# Air New Zealand

## AKL Domestic Terminal – Affordable Pathways Final Report

Arup has undertaken a review of the Integrated Domestic Terminal (IDT) proposal and rapid development of alternative Domestic Terminal pathways over an 8 week period.

# 6. Pier Width

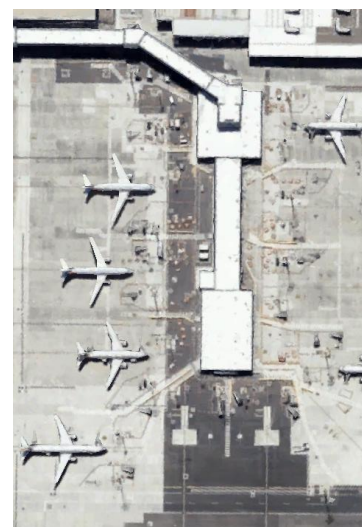
Airport	Pier Width
LaGuardia Terminal B	36m
Auckland IDT	33m
Christchurch Domestic	27m
Perth T1 Domestic	22m – 36m
Montreal Domestic	20m – 27m
Melbourne T4	11m – 22m
Wellington Domestic	6.5m – 20m
Brisbane Domestic	7.5m

# 9. IDT Airfield

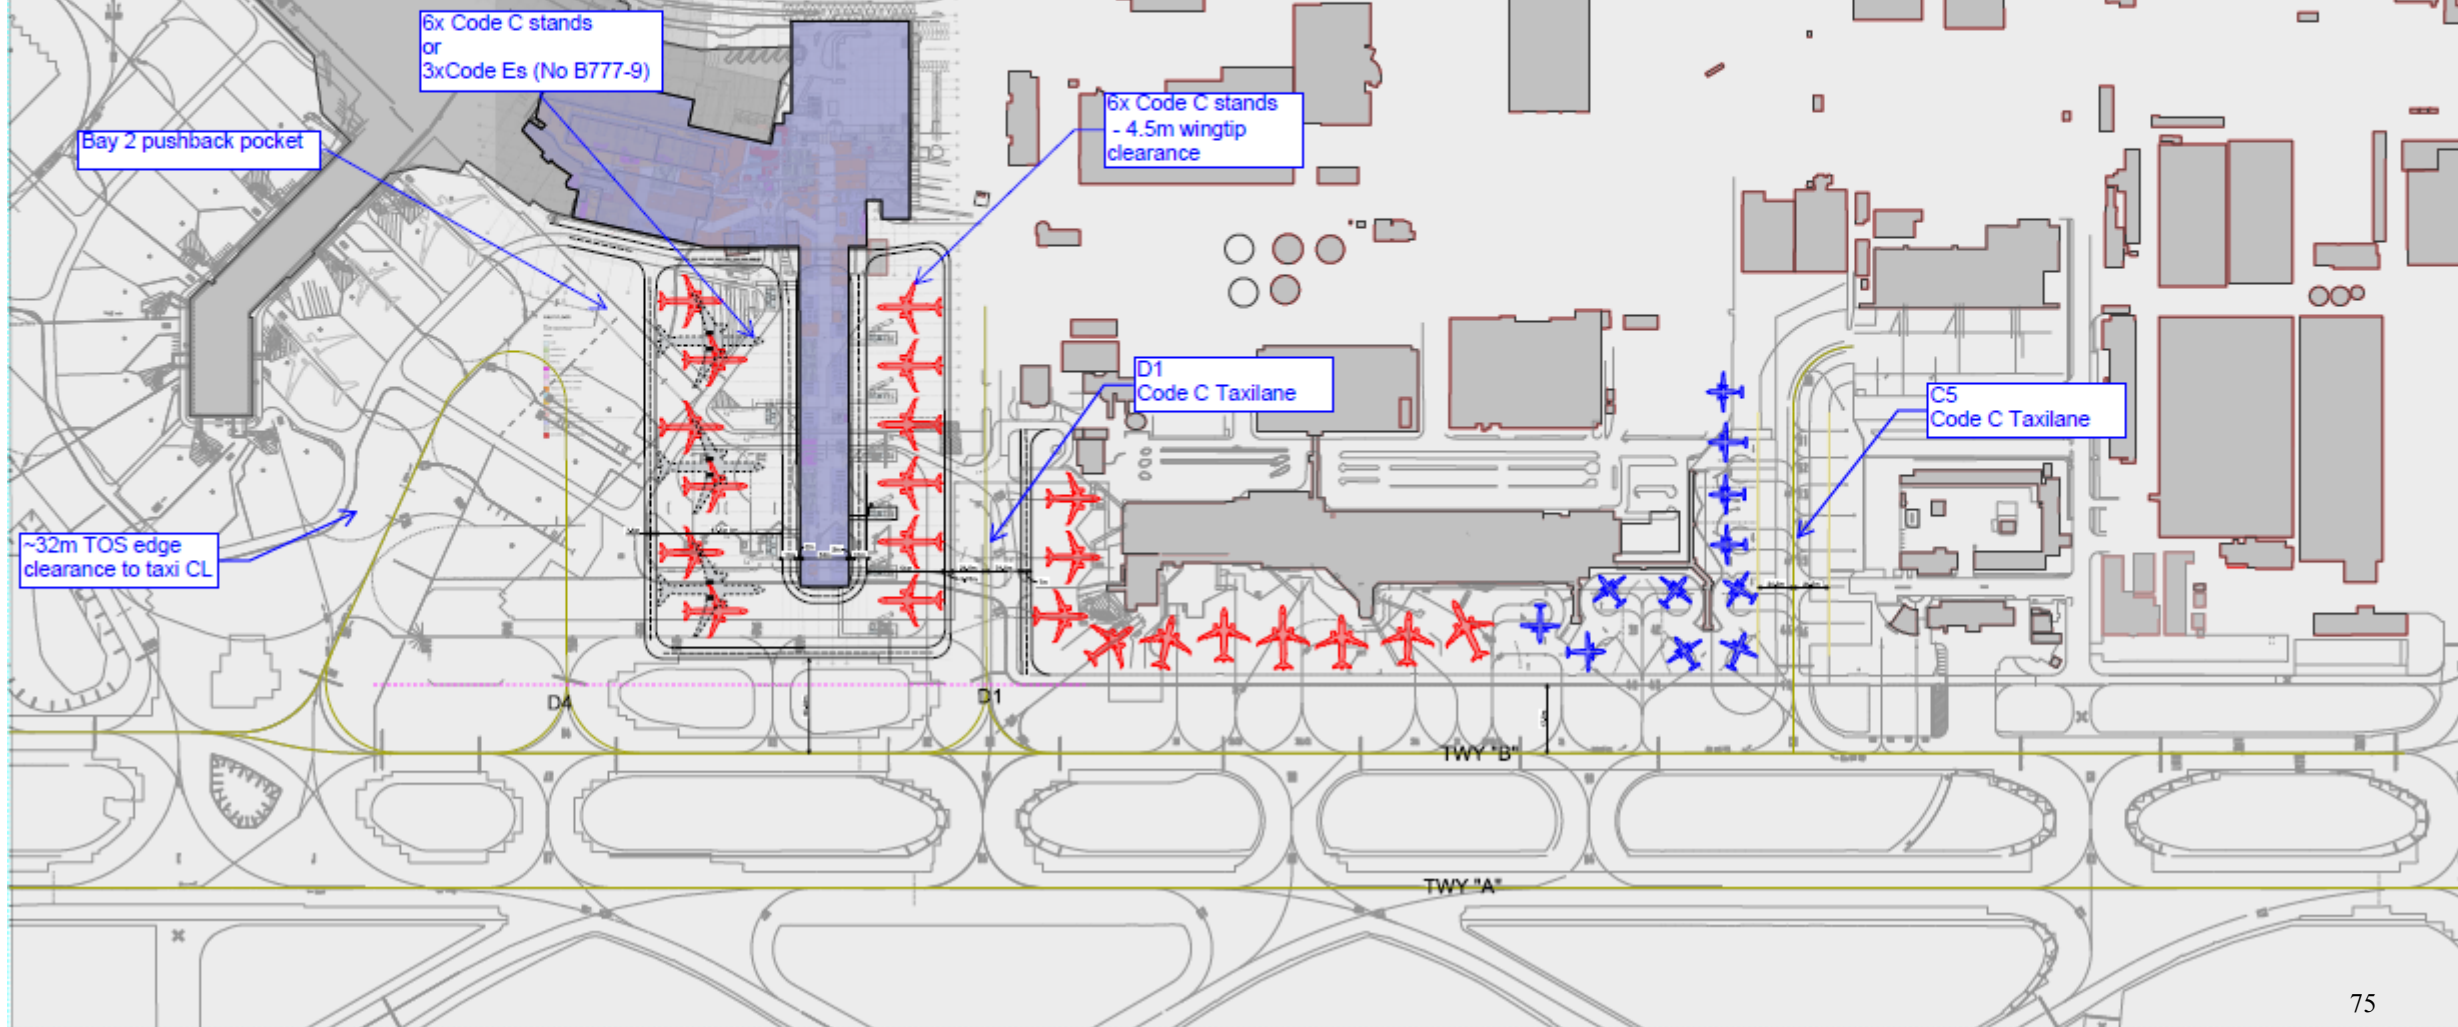
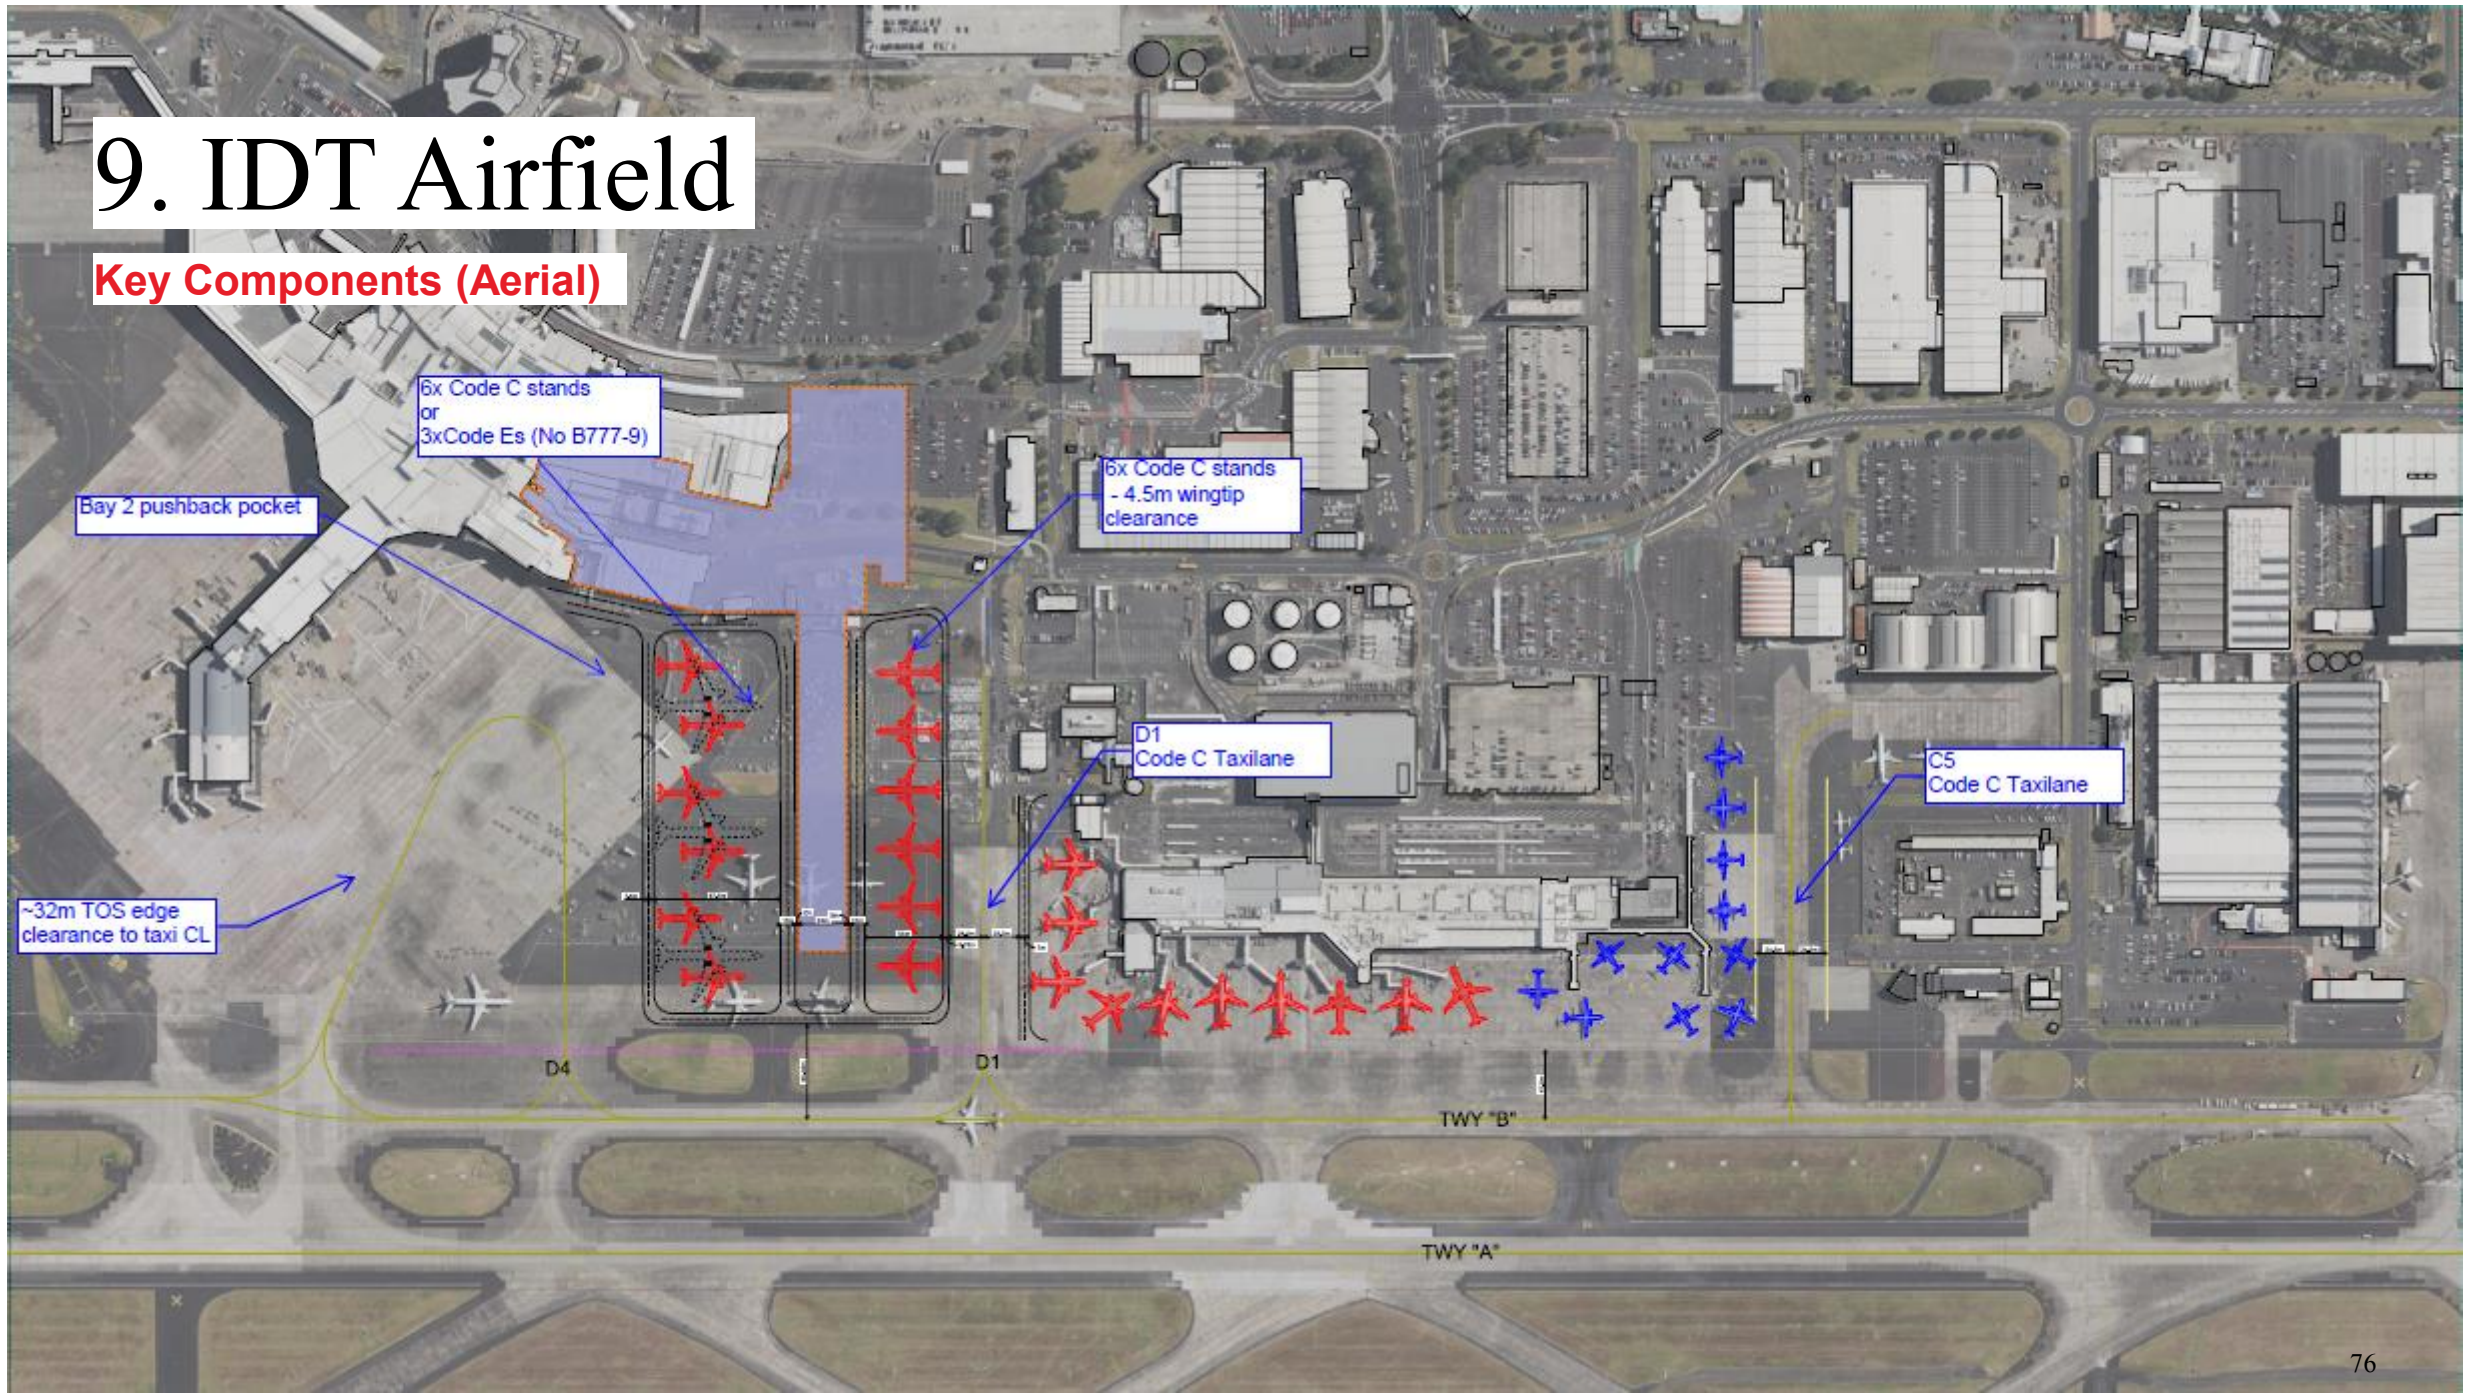
It is noted that the proposed IDT layout does not provide sufficient space for a dual taxilane between the DTB and IDT, as the AIAL Masterplan ultimately envisages demolition of the DTB.

- The proposed IDT includes a single taxilane between Pier A1 and the DTB as the AIAL Masterplan envisages demolition of the DTB in the early 2030s.
- Arup has provided a revised alignment of Pier A1 that provides sufficient space for a dual taxilane, thereby improving airfield operations

# 9. DTB plus Pier A1 – Revised Alignment

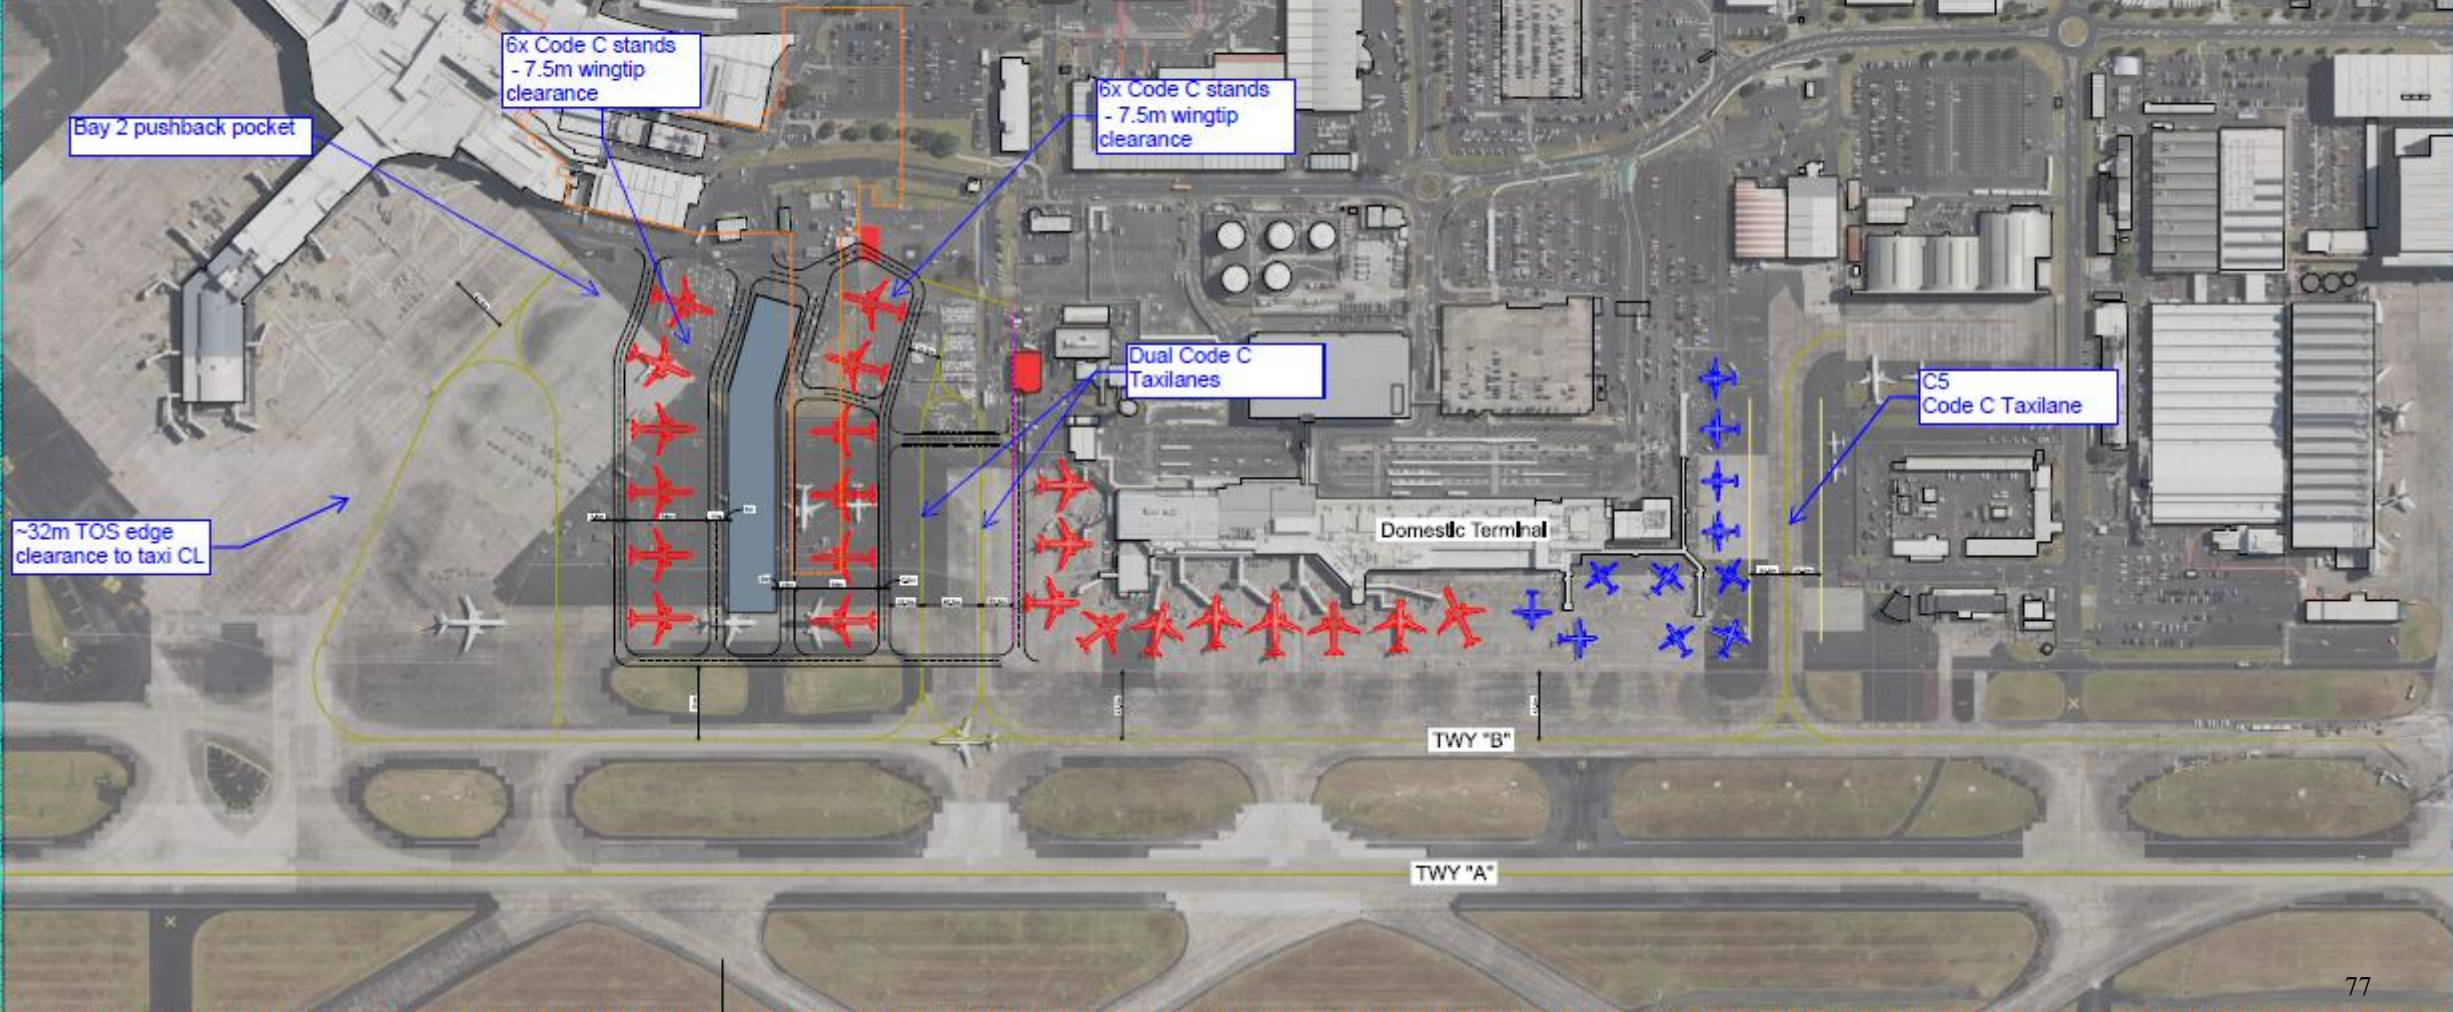
- The revised alignment of Pier A1 can provide 12 Code C jet stands, or alternatively 8 Code C Jet stands and 2 Code E stands in a MARS arrangement.
- An option with DTB + A1 + A3 + Regional Headhouse can provide up to 20 Code C Jet stands and 16 turboprop stands but the Regional headhouse impacts on the “KFC” and adjacent hangar facilities.
